PERMIT

SEWAGE DISPOSAL SYSTEM

HOWARD COUNTY
BUREAU OF ENVIRONMENTAL HEALTH
461-9933

SUBDIVISION Glenwood Springs ROAD 2818 Glenwood Springs Dr LOT 40

#40

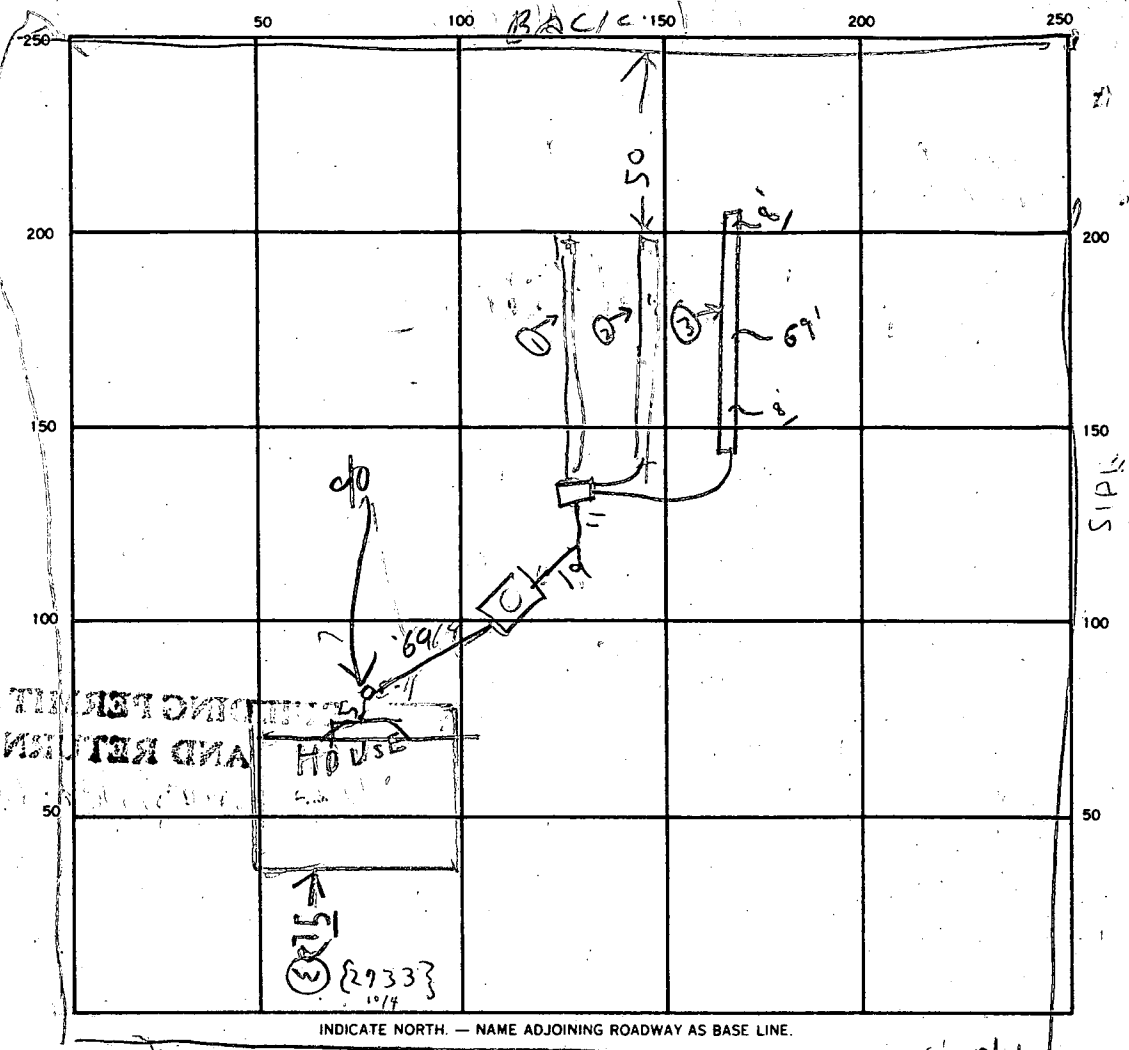
REMARKS 8/3/88 - LOCATION OK PER PLAN - FINISH ADDING STONE TO TRENCH #1 & #2 DIG TRENCH #3 & CALL. RH

10/4/88 ① SOME STONE IN TRENCH ONLY; NO PIPE; NO WORK SINCE

EARLY 10/7/88 ③ TRENCH OK FOR STONE ONLY; PARTIAL; NEED TO SEE ALL

PIPE AND DIST. BOX - DO NOT COVER ANY WORK YET; LEFT STICKER. NEED 4' MORE OF TRENCH ON ③. c.B. 10/14/88 INSPECTION FOUND ③ TRENCH C.B. 69'
